RE: Waste Rock Site Culvert, Canyon Fuel Company, LLC, Skyline Mine, C/007/005, Task ID 4978

Attached to this letter is pertinent information addressing modifications to the Skyline Mine M&RP to include the installation of a culvert at the Waste Rock Site. The culvert will carry runoff from the undisturbed ditch, UD-6B, to the adjacent natural drainage. The permit modifications consist of: 1) referencing the addition of the culvert in Section 3.2; 2) updates to Plates 3.2.8-1 and 3.2.8-2 to show the culvert; 3) the addition of Plate 3.2.8-1a detailing the culvert design; 4) updates to the bond calculations in Section 4.3 to accommodate the demolition and disposal of the concrete, culvert, and backfilling; and 5) relevant design information for the culvert.

Title: Waste Rock Site Culvert Task ID #4978

Description, Include reason for application and timing required to implement:
Addition of culvert from undisturbed ditch to existing drainage

Waste Rock Snow Removal Plan

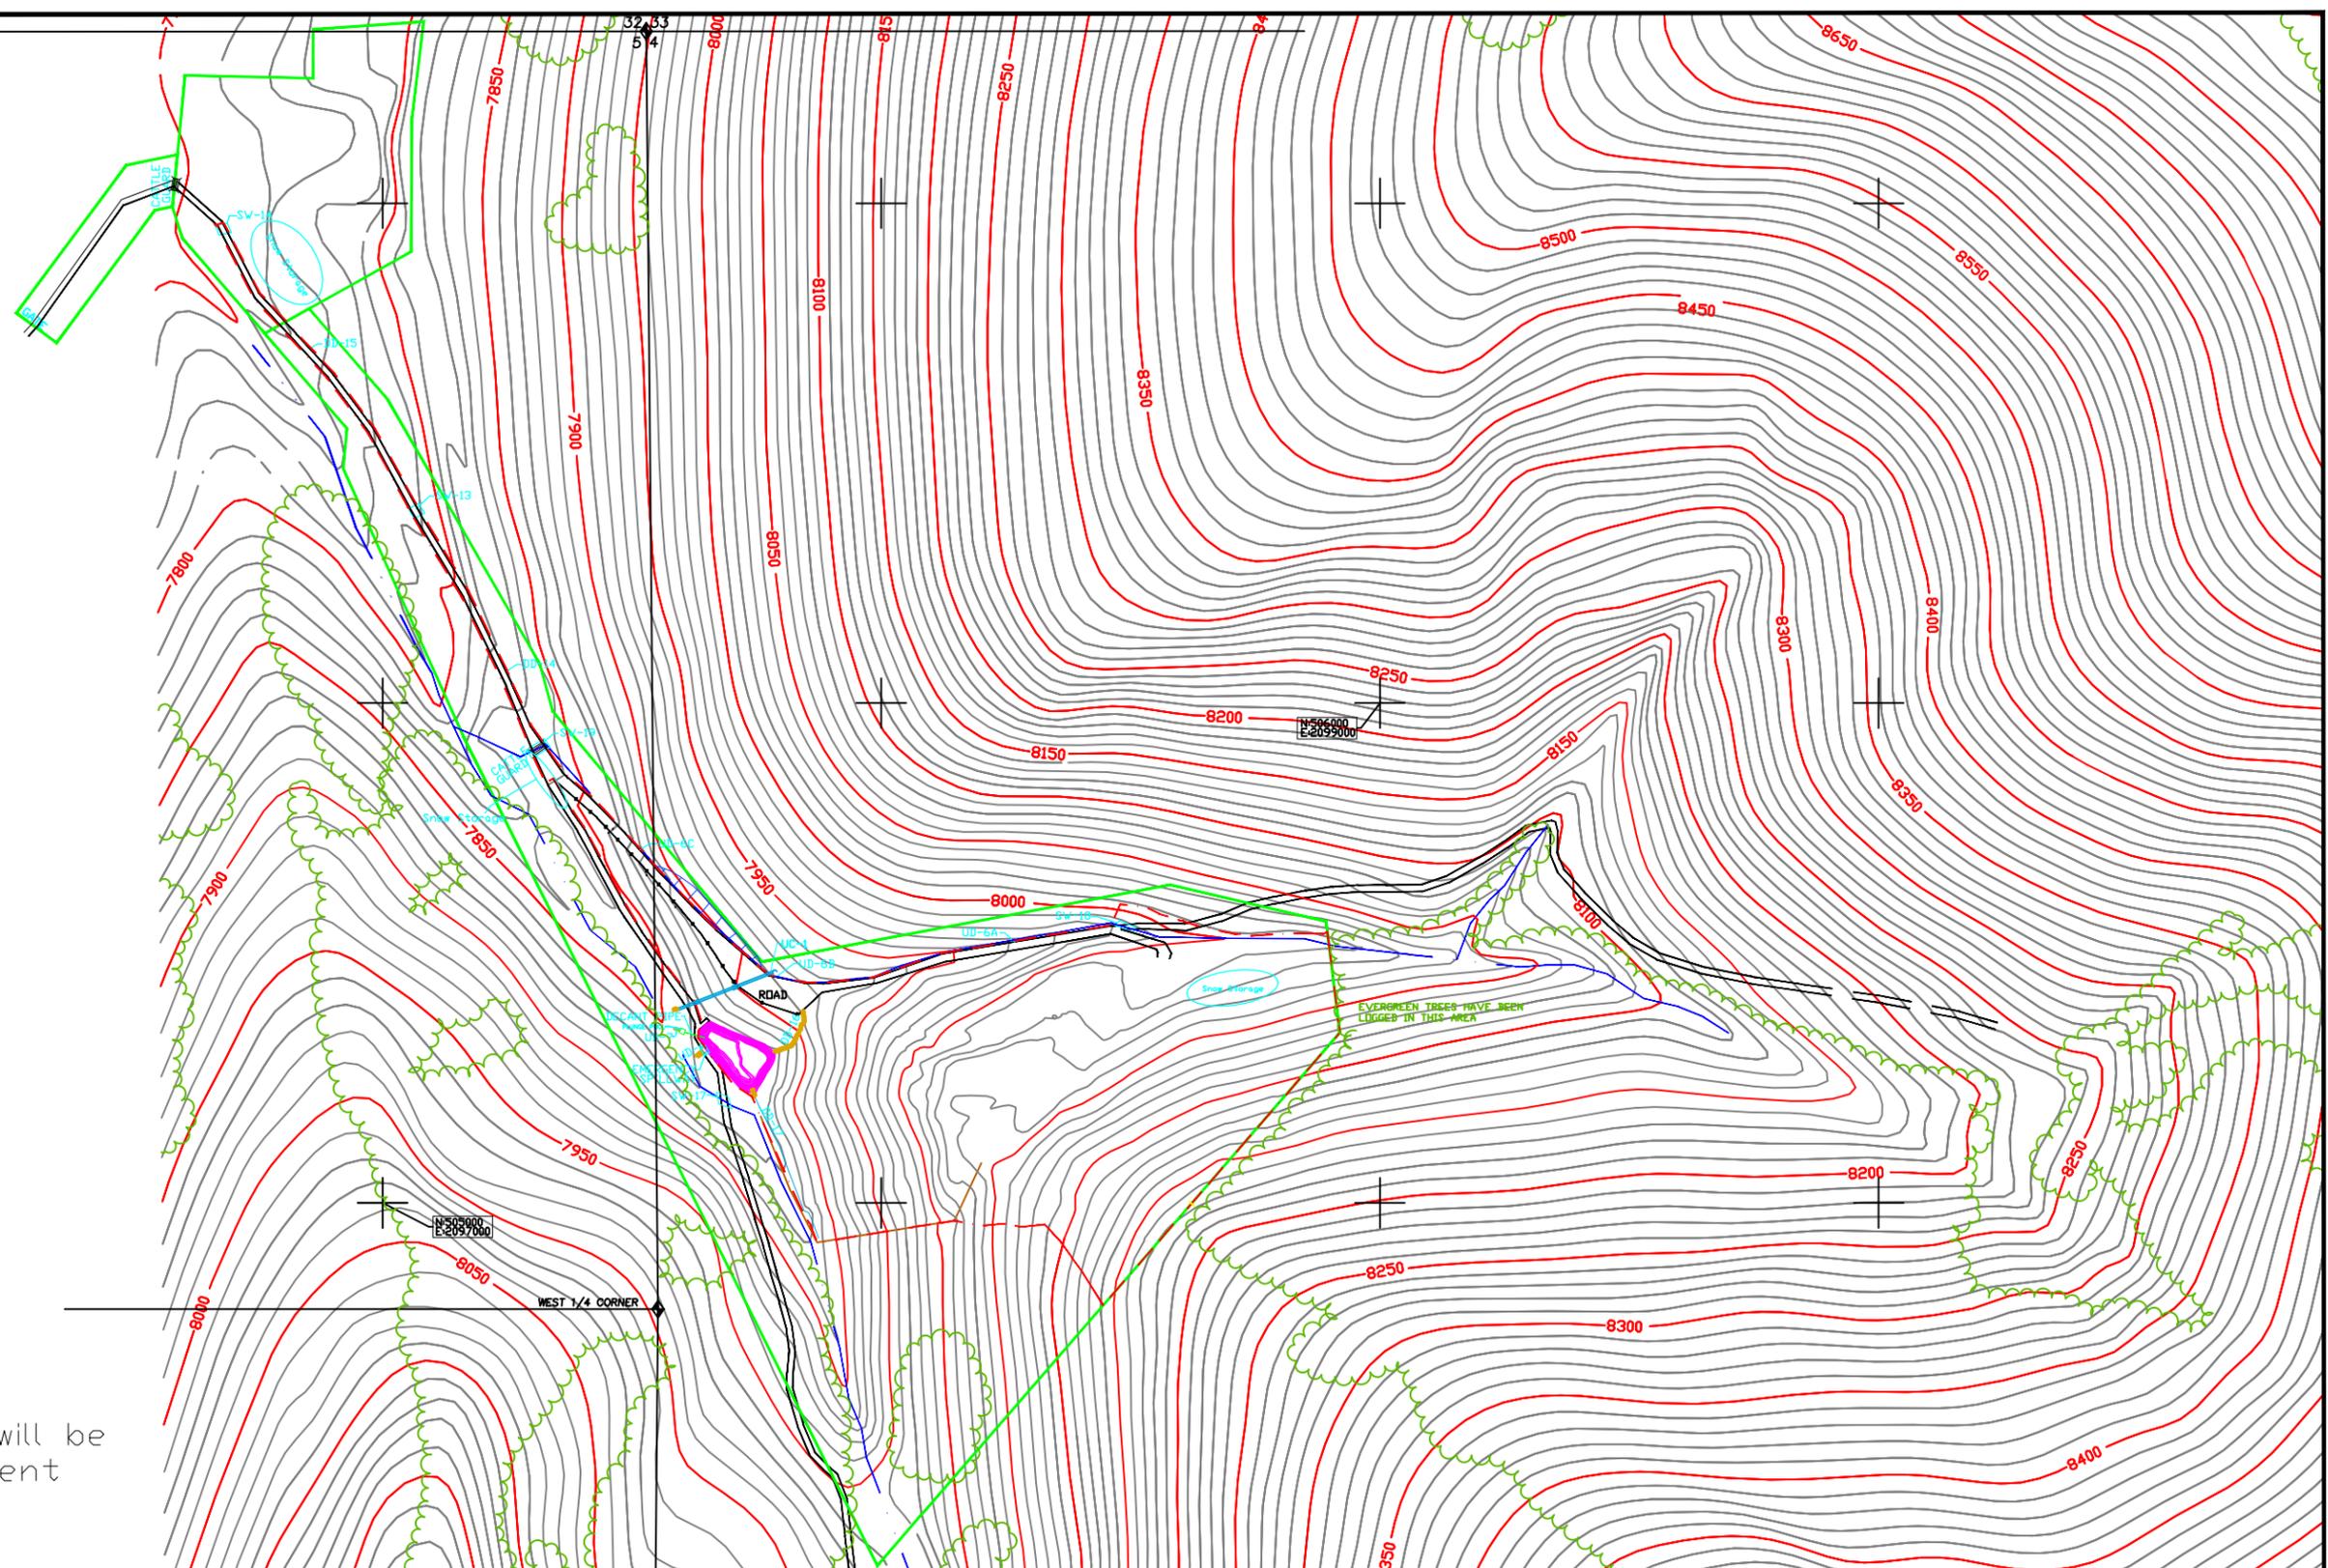
DATE	No.	REVISIONS	APPD.	CHKD.	DES.	DR.
09-14-15	10	ADDED UC-1	/		J.A./J.A.

WASTE ROCK FACILITIES

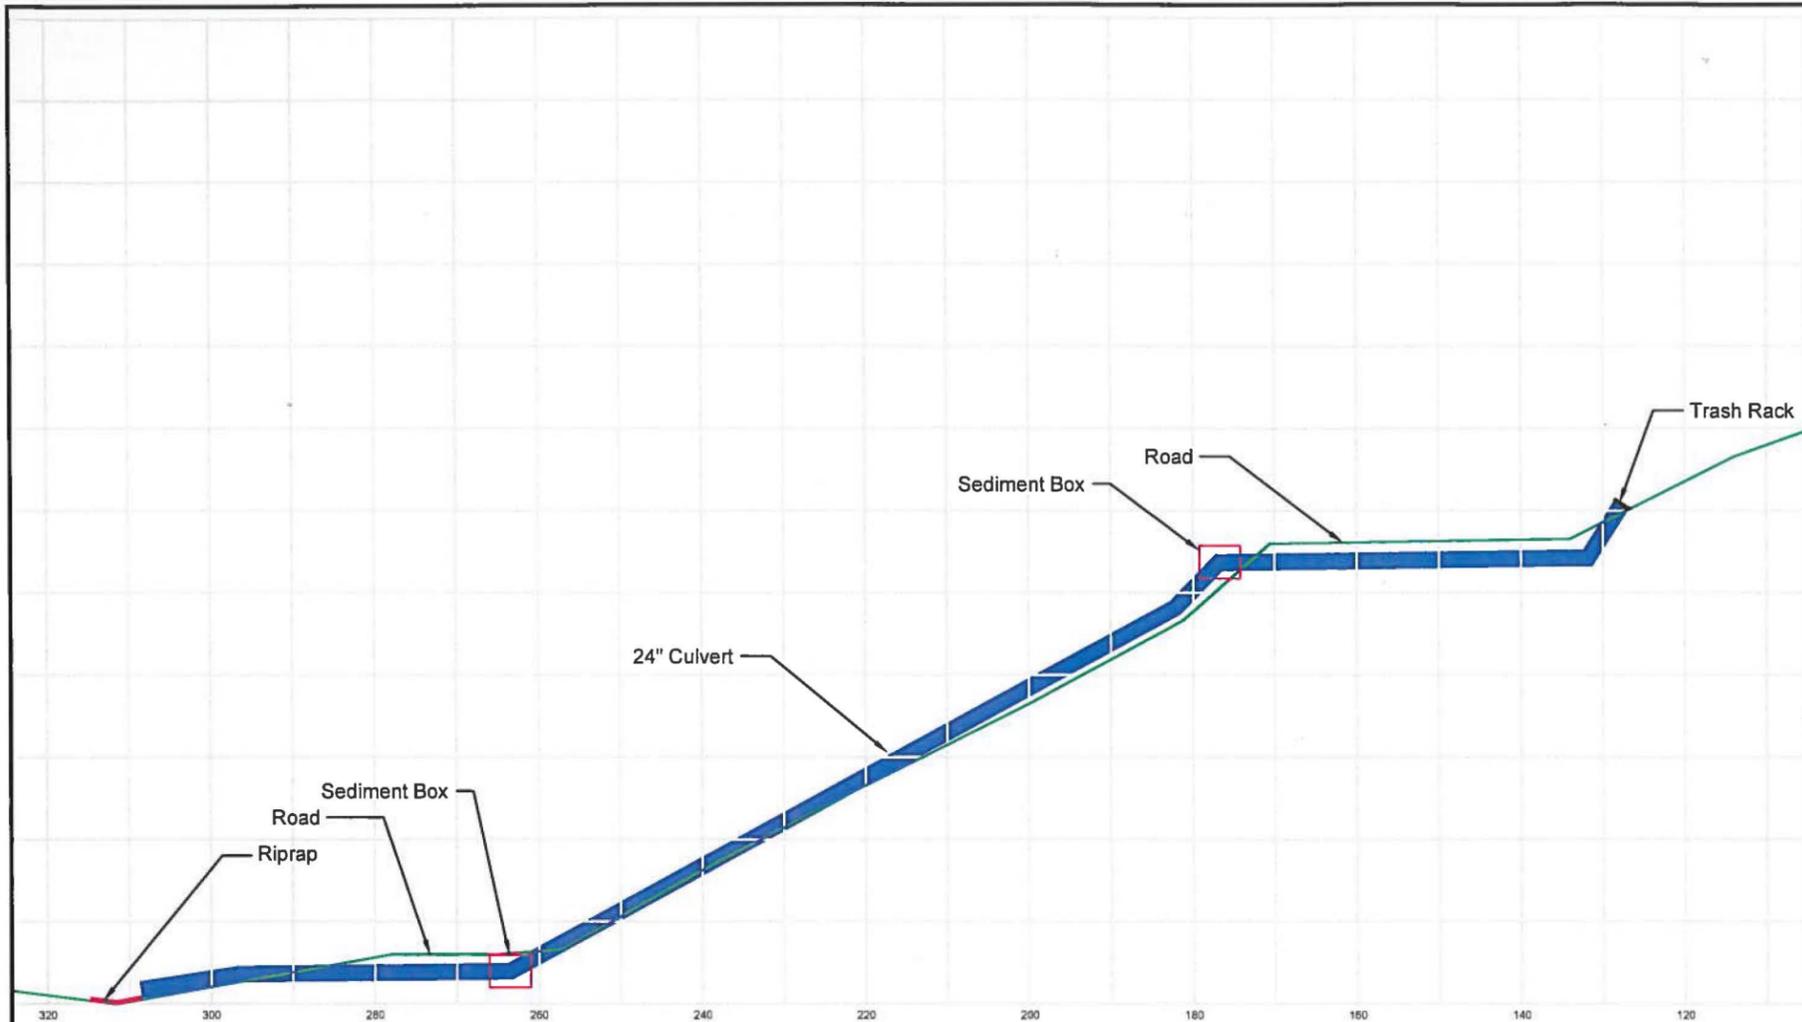
DATE	No.	REVISIONS	APP'D	CHK'D	DR.
7-89	1	ADD AREA 24-A			
9-20-89	2	DITCH NUMBER'S CHANGED			
9-29-89	3	NOTE ADDED			
7-1-92	4	REVISED FOR PIT EXPANSION			
5-19-94	5	ADD AREA 24-A			
5-02-07	6	ADDED EXPANDED PERMIT AND DISTURBED AREA, AS-BUILT SEDIMENT POND, AND UNIMPROVED ROAD			G.C./B.R.
5-15-14	7	ADDED Topsoil/Subsoil Piles, Removed "Access Road" from title block			G.C./C.C.
9-9-15	8	ADDED UC-1, ADDED EXPANSION AREA FROM PLATE 3.2.8-2			B.B./B.B.

Waste Rock Site Culvert and Riprap Design			
Canyon Fuel Company, LLC Skyline Mines			
HCR 35 BOX390, HELPER, UT, 84526 435-448-2632	DATE: 09/09/15	CK.BY: JArmstrong	REVISION:
DWG. NO.: 3.2.8-1a	SCALE: NST	DR.BY: BBAILEY	0
CAD FILE: P:\PERMITS\SKY\WORKING\2015_WRS_culvert\3.2.8-1a			09/09/15

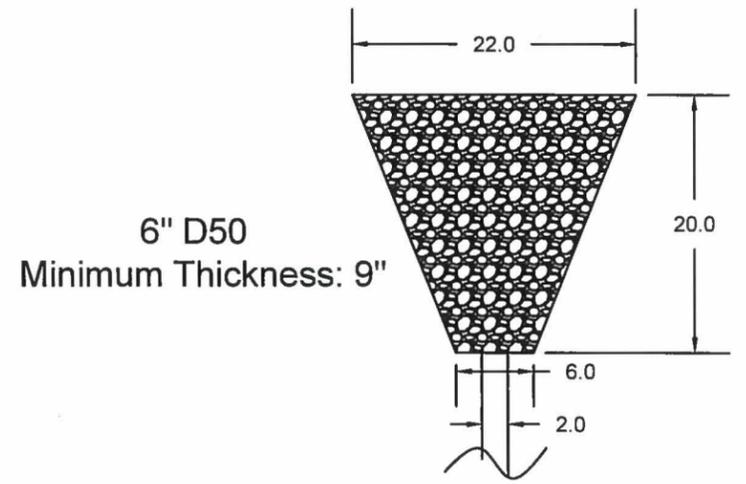
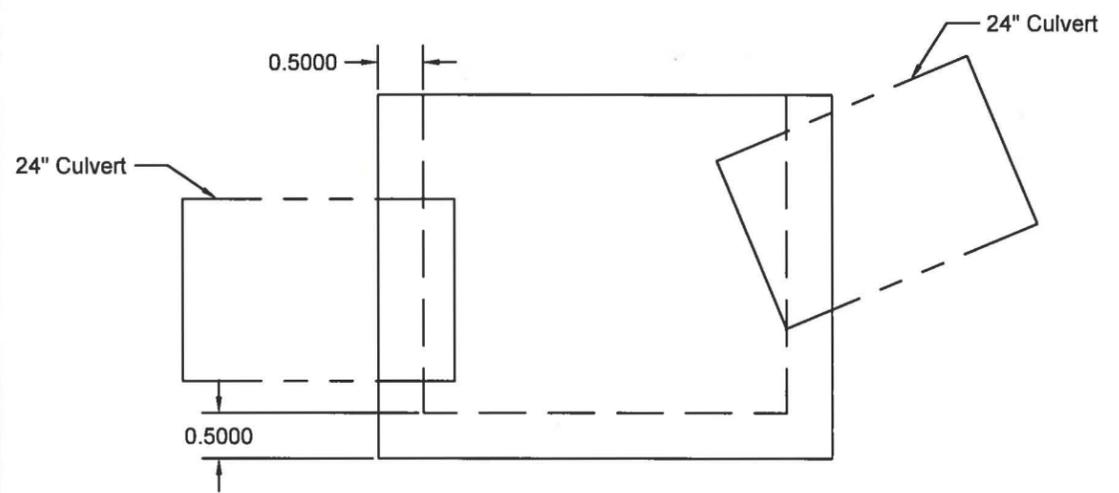
Outlet Riprap Design

Concrete Sediment Box

WASTE ROCK FACILITIES AND DRAINAGE CONTROL

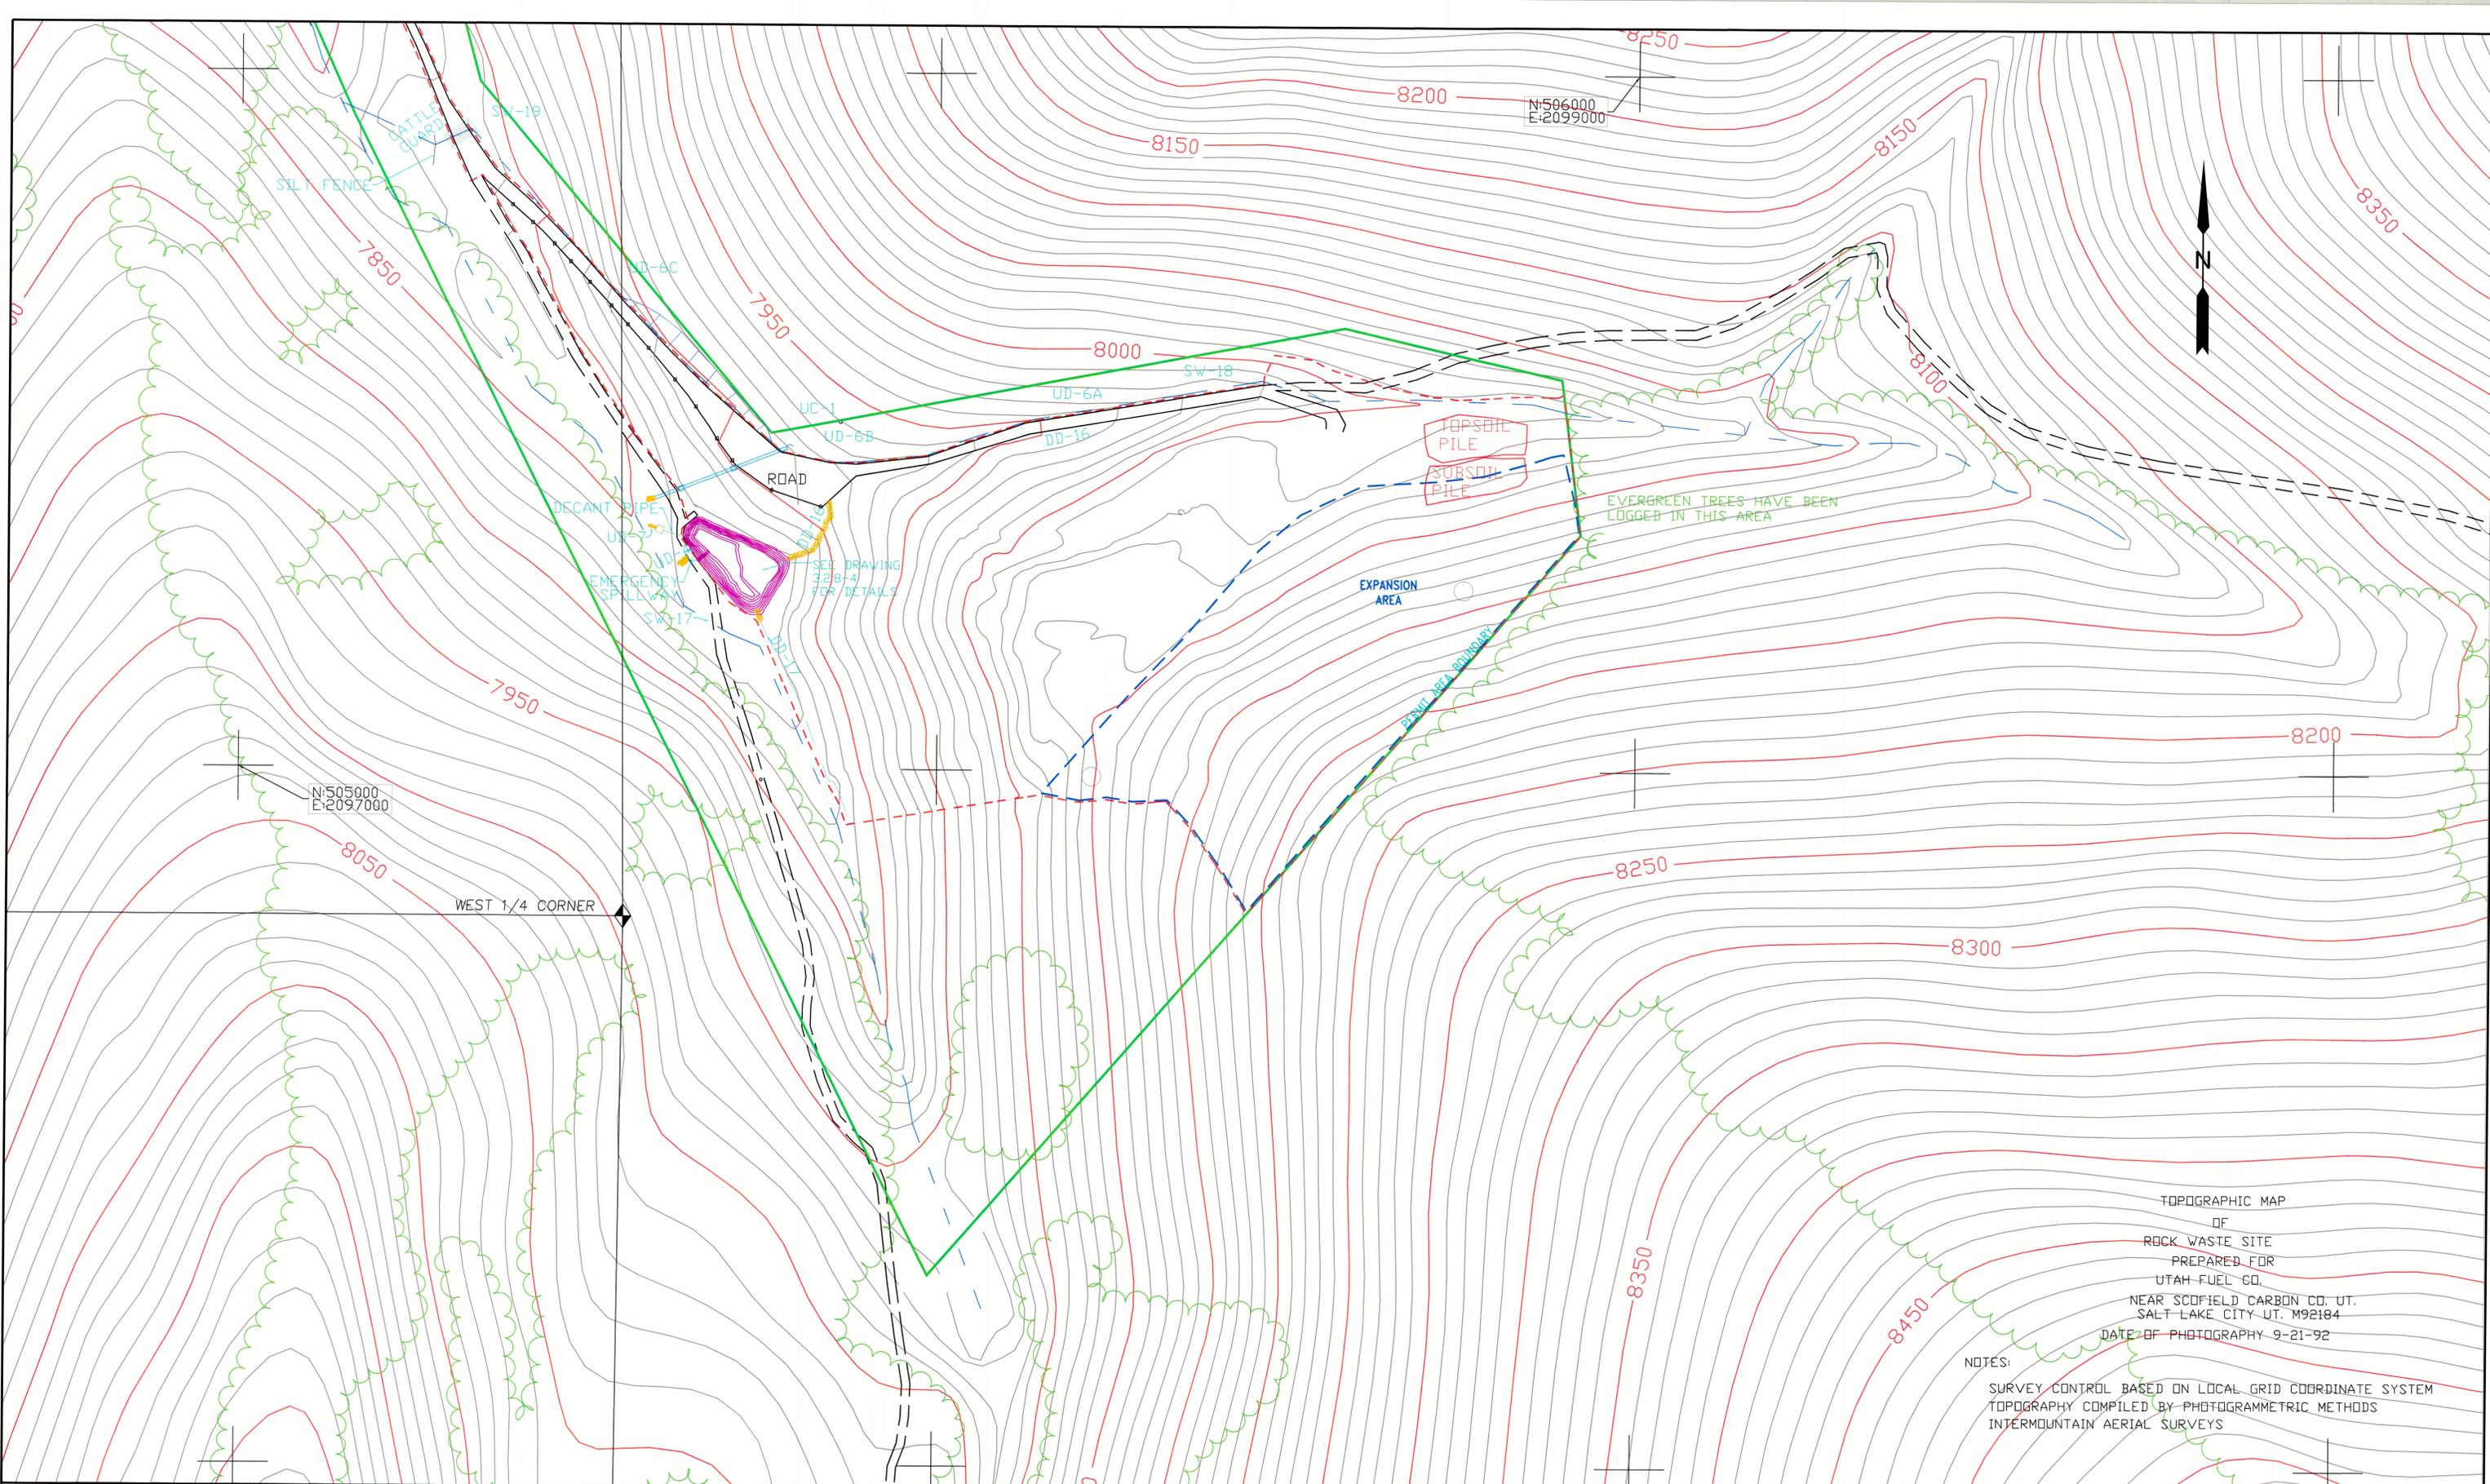
DATE	No.	REVISIONS	APP'D.	CHK'D.	DATE	No.	REVISIONS	APP'D.	CHK'D.
09-1-98	1	SHOW EXPANDED AREA	/	G.T./J.F.	09-14-15	10	ADDED UC-1	/	J.A./J.A.
11-10-98	2	ADDED TOP SOIL STOCKPILE	/	G.T./J.F.				/	
01-11-98	3	SHOW ALL OF PERMIT AREA BOUNDARY	/	G.T./J.F.				/	
04-16-99	4	TEMPORARY DRAINAGE DIVERSION	/	G.T./J.F.				/	
10-12-05	5	REMOVED SILT FENCE ALONG ACCESS ROAD	/	G.G./J.T.				/	
02-01-06	6	REMOVE ROAD LINES, FIX TITLE BLOCK	/	G.G./J.T.				/	
05-02-07	7	ADDED EXPANDED PERMIT, DISTURBED, AND PILE EXPANSION AREA, AS-BUILT SEDIMENT POND, AND UNIMPROVED ROAD.	/	G.G./B.R.				/	
05-09-08	8	ADDED TOPSOIL PILE, MODIFIED EXPANSION AREA LINE	/	G.G./G.G.				/	
05-15-14	9	Relocated one topsoil pile, ADDED subsoil pile	/	G.G./G.G.				/
